CALIFORNIA COASTAL COMMISSION

A-5-SNP-19-0154 & 5-20-0152 (Murthy)

DECEMBER 15, 2021

EXHIBITS

FOUNDATION PLAN - HOUSE
SCALE: 1/4" = 1'-0"

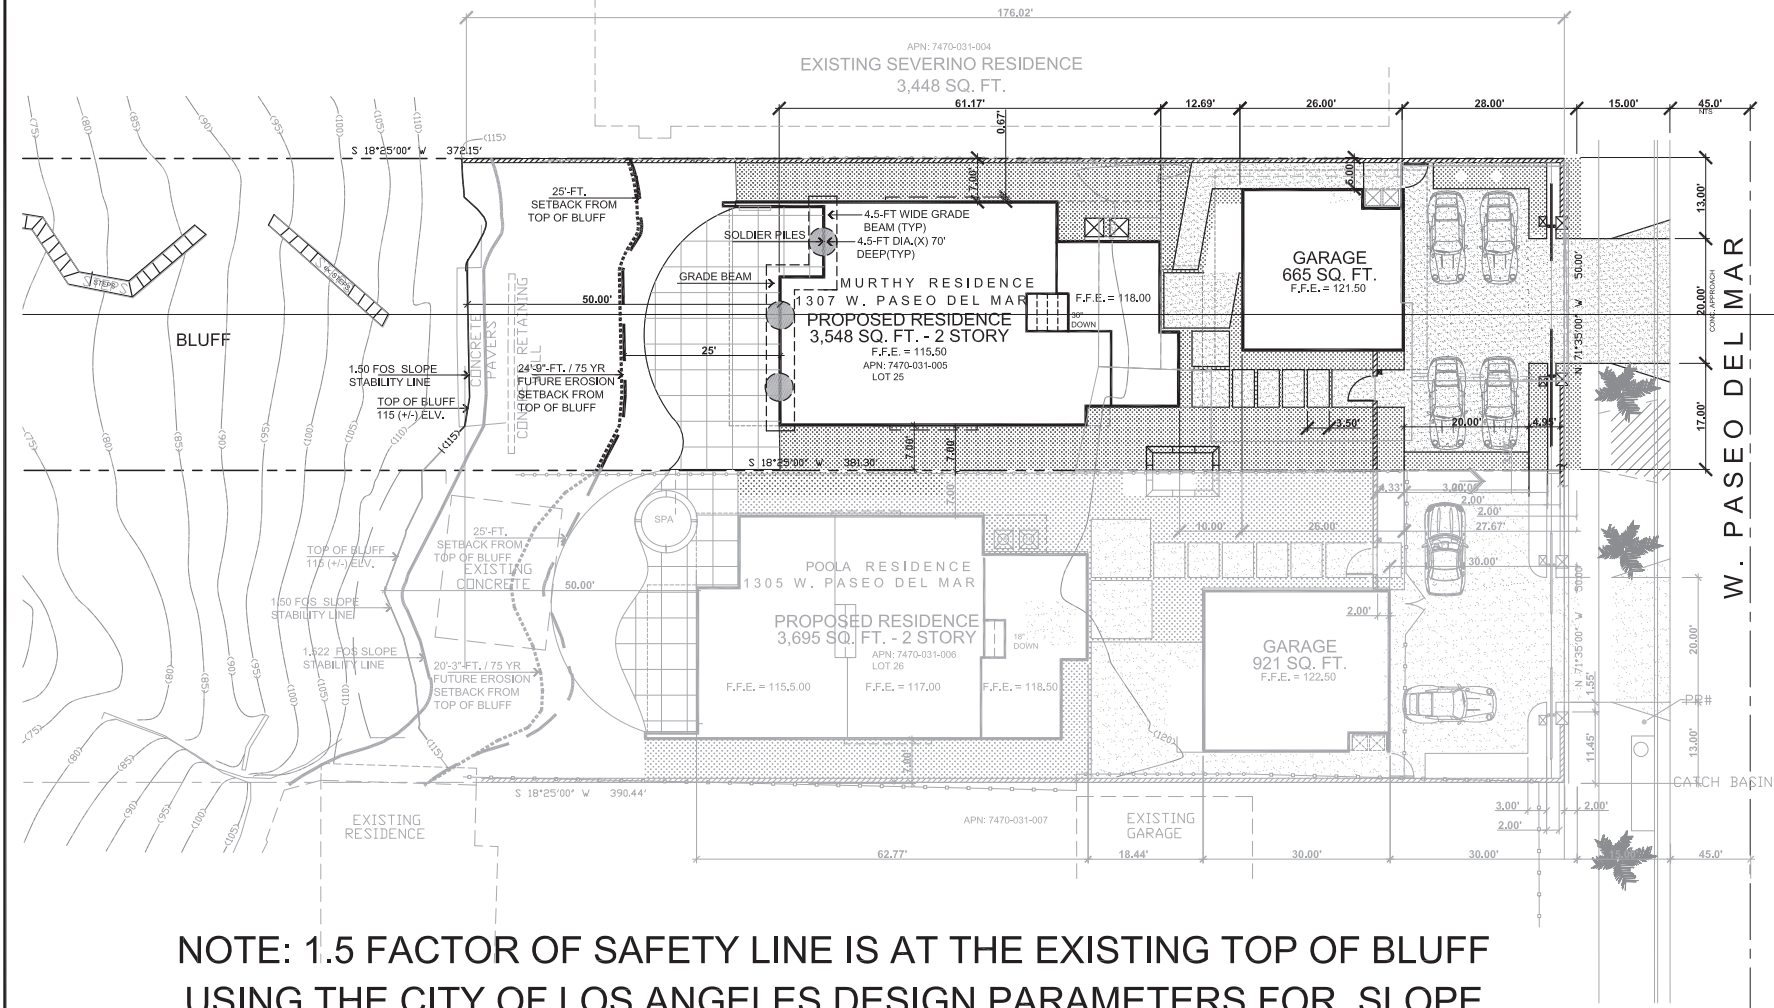
- 1) The development relies on the installation of a massive soldier pile wall in order to achieve the required 1.5 factor of safety, and soldier piles, or caissons, are considered shoreline protective devices, with the approval of the Coastal Commission for new development. Because caissons usually become exposed

structures would, new development cannot rely on them to assure structural stability or to determine a safe bluff setback. Instead, the structure must be set back far enough from the bluff edge to be safe over its projected lifespan, eg. 75 years. Sea level rise in combination with dramatically increased storm activity should be factored in when projecting the rate of erosion.

Given the proposed size of the house and garage, a safe setback without a deepened caisson foundation achieving a 1.5 factor of safety won’t be possible. The house and garage must be reduced to a size that will allow them to be sited far enough from the bluff edge to achieve the required factor of safety without a deepened caisson foundation.

NOTE: 1.5 FACTOR OF SAFETY LINE IS AT THE EXISTING TOP OF BLUFF
USING THE CITY OF LOS ANGELES DESIGN PARAMETERS FOR SLOPE
STABILITY AND USE OF SOLDIER PILES UNDER THE PROPOSED BUILDING

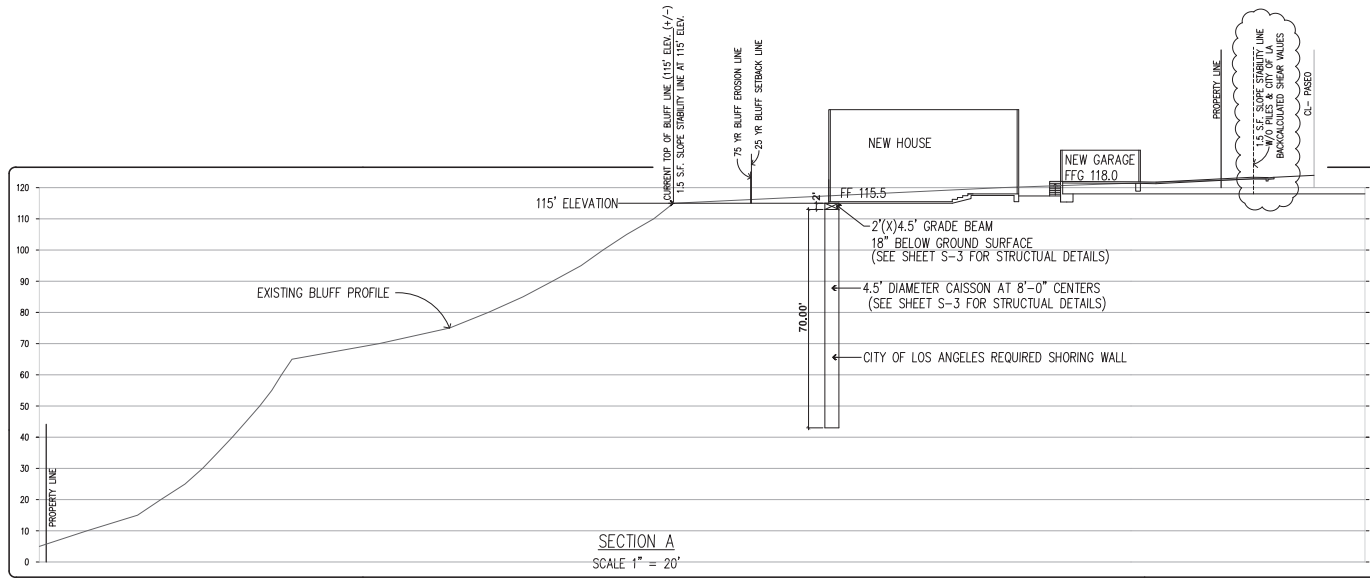
Based on these analyses, the bluff failure event most likely to occur at the site in the future is a reactivation of the existing landslide on the previous slide plane, for which the calculated static factor of safety was 1.0 – 1.2 (with a pseudostatic or "seismic" factor of safety of $<<1$) (Refs. 1-3). However, a reactivation of the landslide would not, on its own, directly affect the proposed residences, which would be sited more than 50 feet inland on the unfailed portion bluff.
